Applies To 500, 650, and 750 Ton AC Top Drives

Product Bulletin # 124

# **Elevator Alarm Position Sensor Clamp Replacement**

Figure 1: Position Sensor Mounted on Top Drive Guard's Crossbar

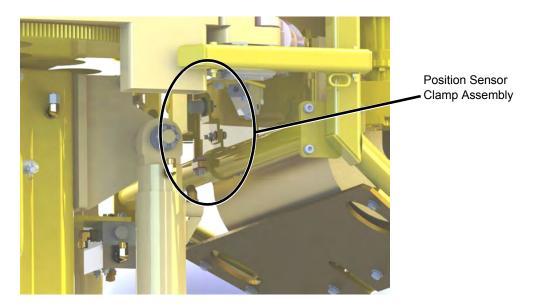
The elevator alarm position sensor clamp assembly on 500T/650T/750T AC top drives could possibly interfere with the hydraulic fittings on the link tilt cylinders when they are fully retracted and the pipe handler is rotated. While the practice of fully retracting the link tilt cylinders when the handler gear is rotated is not recommended by Canrig, the position sensor clamp assembly has been redesigned to prevent this interference from occurring.

The new position sensor clamp assembly may be installed to eliminate any possibility of interference. Refer to Figure 1 below for an example of a mounted top drive position sensor.

The pipe handler should not be ro tated while the link tilt cylinders are fully retracted. Equipment damage can result.

Figure 4: Position Sensor Clamp Installation

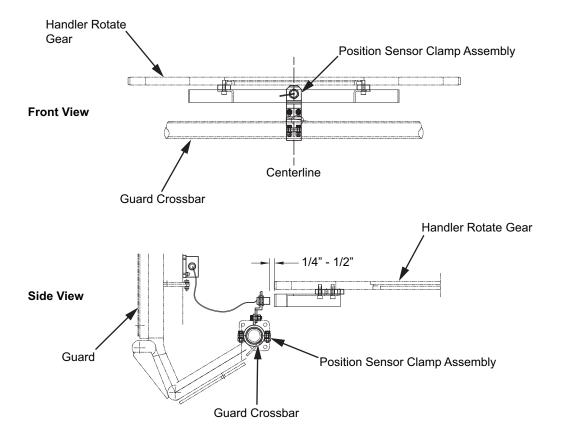
Remove the old top drive position sensor clamp (Canrig Part # DT14605-1) from the top drive guard's crossbar and replace with the new clamp parts (Canrig Part #'s DT31702 and DT31703). The original position sensor, position sensor mount, and fasteners can be reused for the new assembly if they are not damaged. Contact Canrig Sales to order the replacement parts.

Refer to Figure 4 on page 3 for specific mounting information.
